RE: **Response to Peer Review Comments**
The Village at Sudbury Station – 30 Hudson Road Sudbury, Massachusetts

MDM Transportation Consultants, Inc. (MDM) has prepared the following response to transportation-related peer review comments for the above-referenced project, as issued in a letter by the City's peer review consultant, Vanasse and Associates, Inc. (VAI), dated March 3, 2016. To facilitate review, specific comments are paraphrased with corresponding responses. Where appropriate, responses provided with input from the Applicant's design team are noted and include Sullivan Connors Associates (SCA) and Winn Residential (Winn).

Exhibit 9

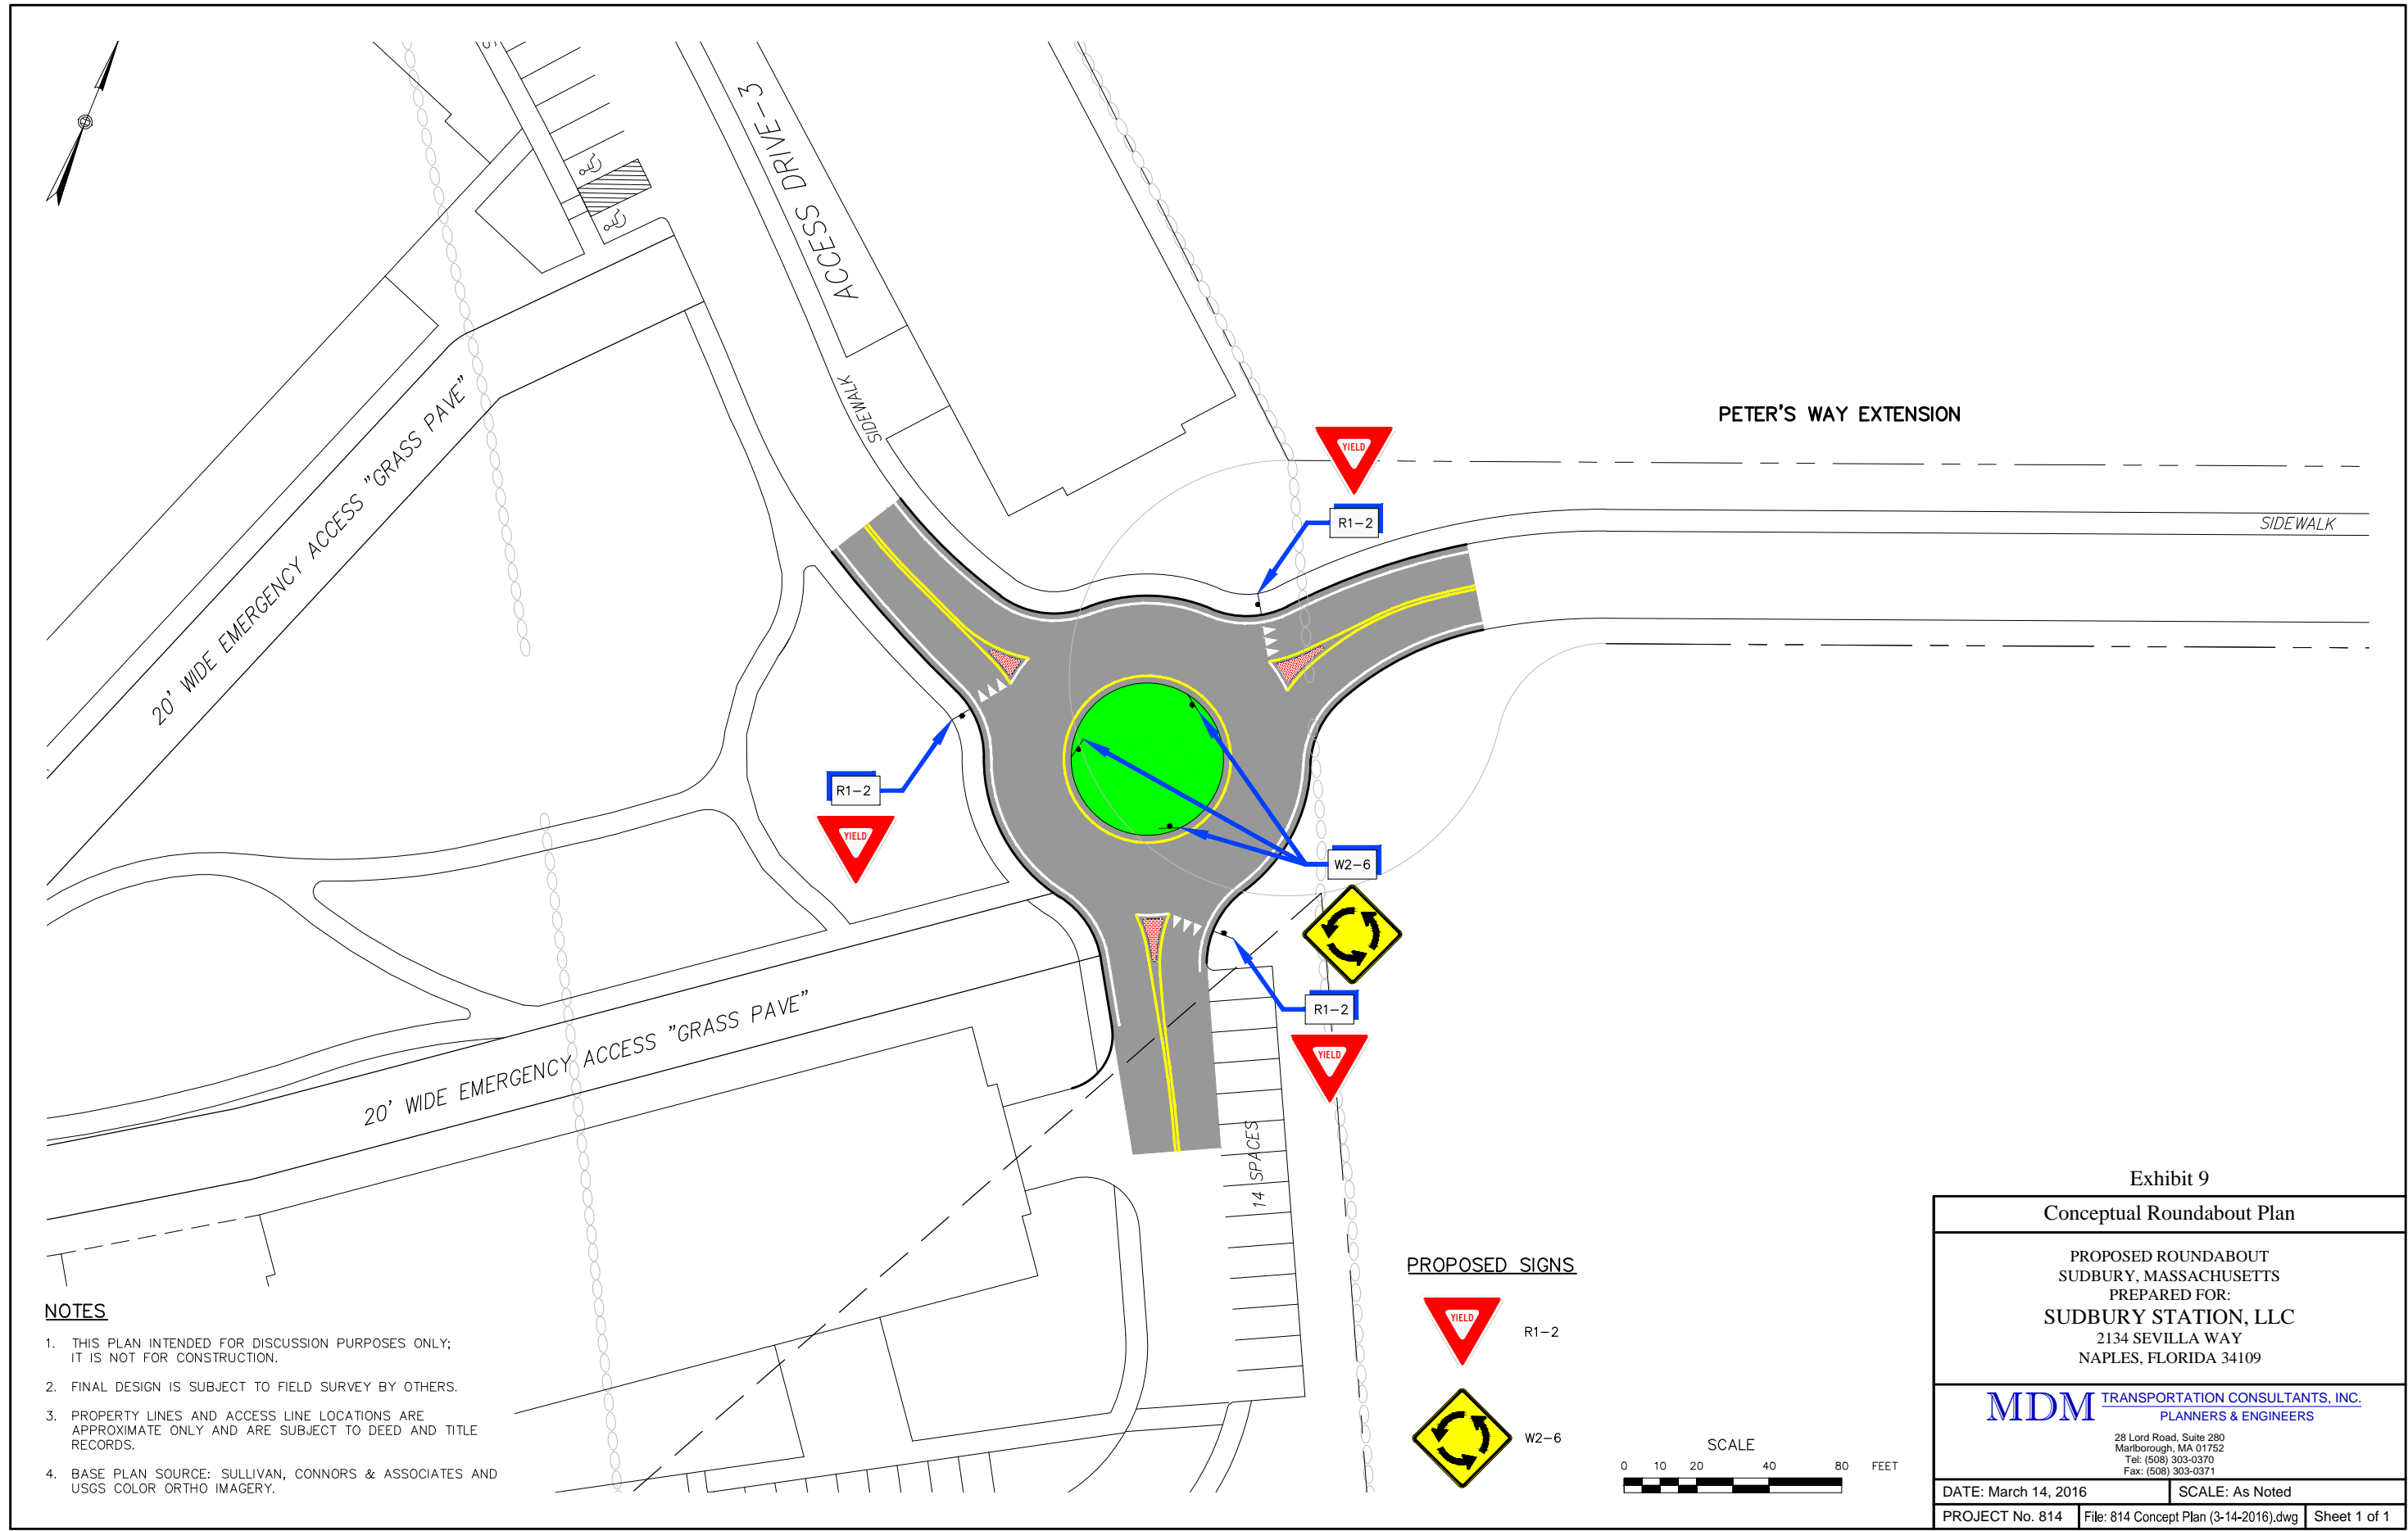
Comment T18: *"The approaches to the modern roundabouts should include raised splitter islands in order to channelize entering and exiting traffic and reinforce the one-way circulation pattern."*

Comment T21: “A sign and pavement marking plan should be provided as a part of the Preliminary Site Plan in order to verify that the proposed traffic control devices are appropriately designed and located within the Project site. This plan should be developed by or in consultation with the Applicant’s Traffic Engineer given the unique signing requirements for the modern roundabouts that are proposed within the Project site.”

Response: A conceptual roundabout design feature and associated signs and markings is presented in **Exhibit 9**. This design feature is incorporated into the latest Site Plans of March 14, 2016 and includes requested “splitter islands”, markings and signs that reinforce the one-way travel path. AutoTurn® analysis discussed under Response No. T11 verifies that this layout provides sufficient maneuvering area for SU-40 trucks and Sudbury’s largest emergency response vehicle (aerial ladder truck). Note that the splitter islands are proposed as flush “stamped” features that allow larger design vehicles to track over them if necessary.

Response: Signs and pavement markings for site driveways and the roundabout feature are shown conceptually in **Exhibit 9** (Conceptual Roundabout Plan), **Exhibit 10** (Conceptual Access/Egress Plan, Hudson Road) and **Exhibit 11** (Conceptual Access/Egress Plan, Concord Road) and have been incorporated into the Site Plans as updated through March 14, 2016. All signs and markings shall be MUTCD compliant as requested. Additional MUTCD-compliant warning signs will be placed for raised crossings if these features are deemed appropriate and acceptable by Town departments.

Exhibit 12

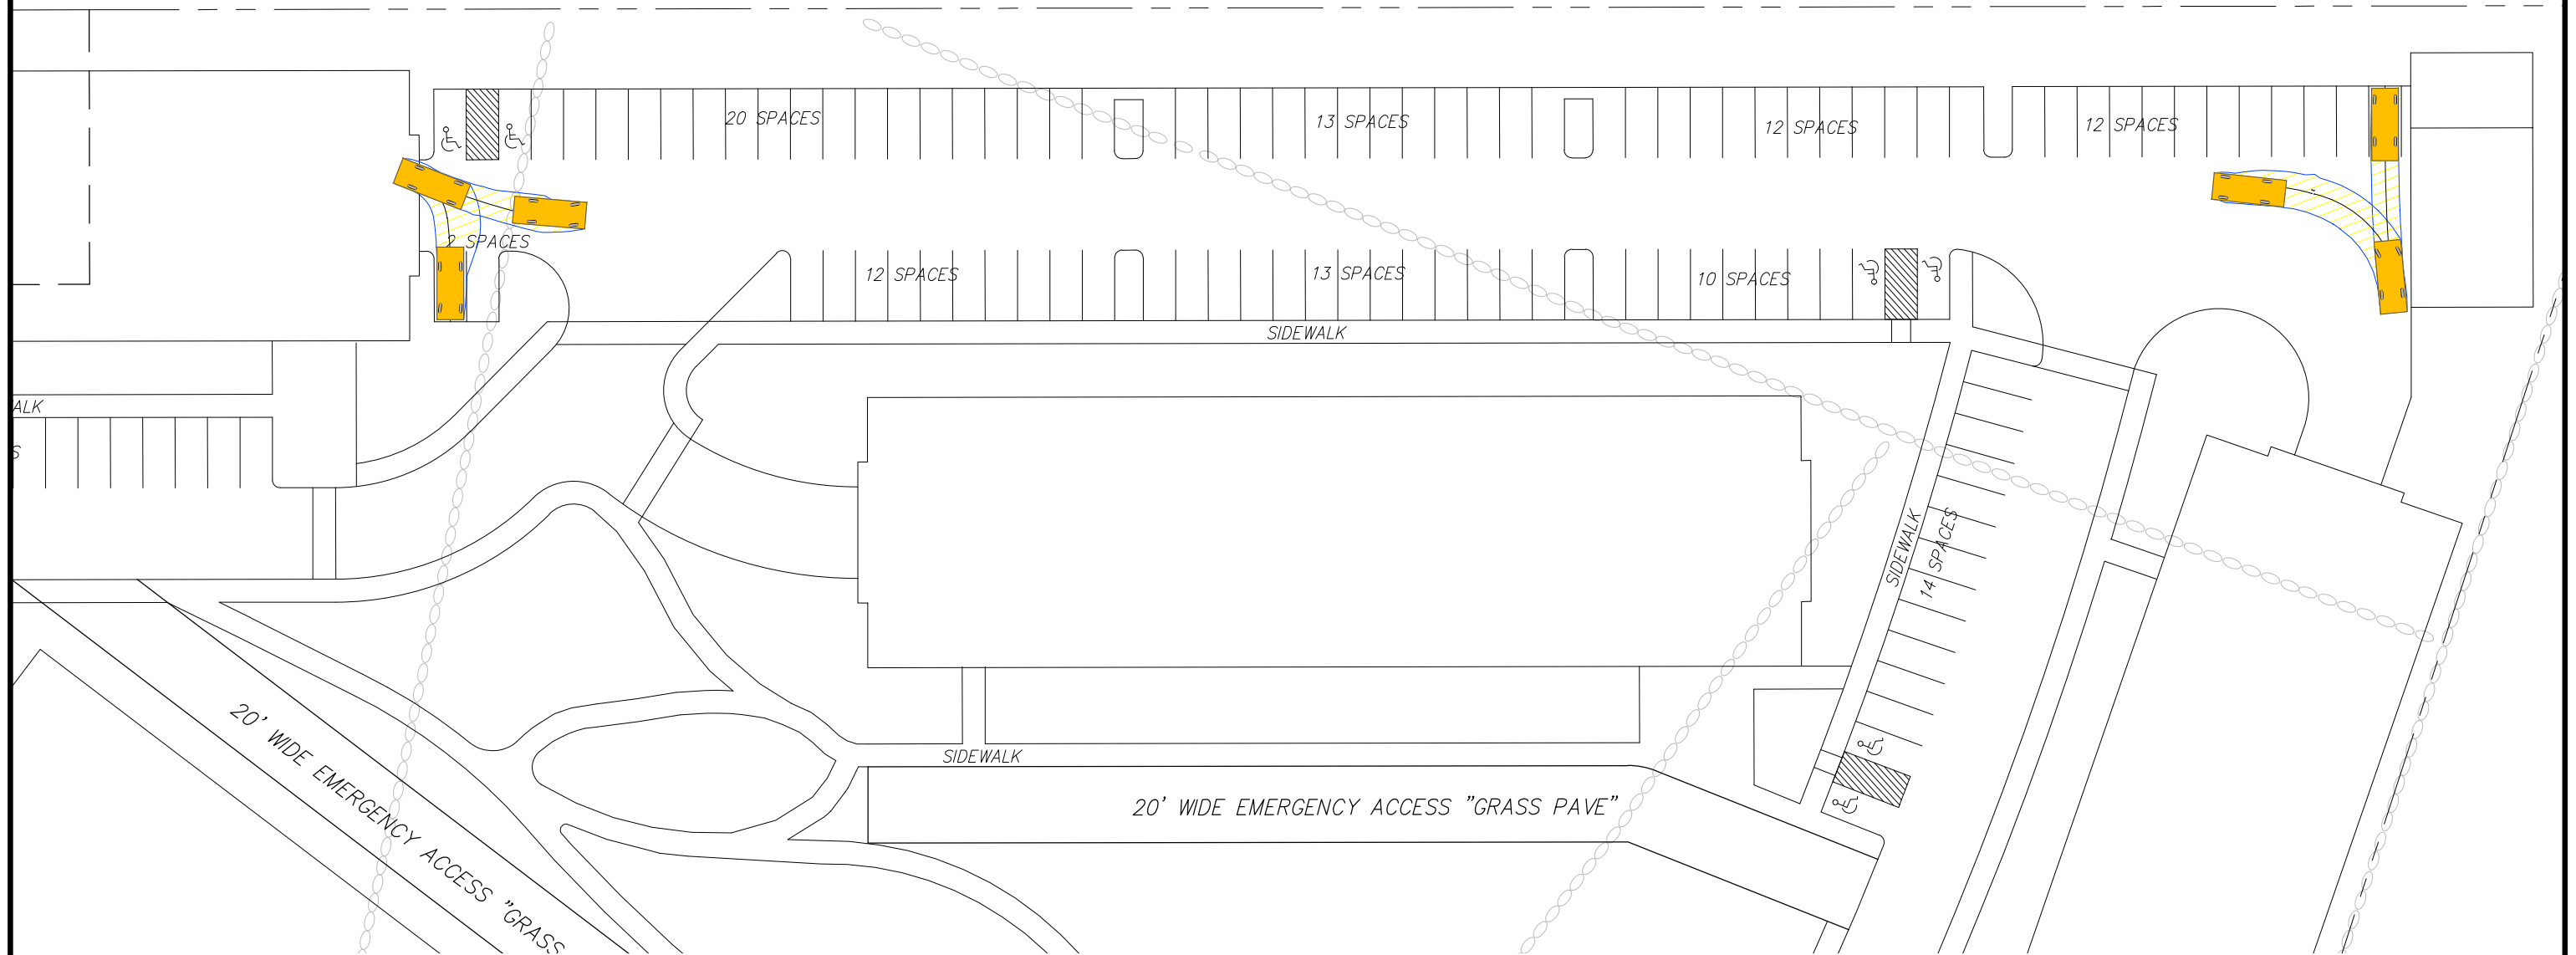
Comment T25: "The Applicant's engineer should review the parking spaces proximate to the trash/maintenance building and Building #1 as the end spaces at both locations do not appear to provide sufficient maneuvering area for vehicles to exit these spaces."

Response: AutoTurn® vehicle turn analysis presented in **Exhibit 12** demonstrates that ample maneuvering area is available at both Building 1 and Building 7 to accommodate vehicle turns into/exiting parking spaces. In the case of Building 1, backing area is available at the garage opening for surface spaces that are closest to the building, essentially serving as a "hammerhead" for maneuvering purposes.
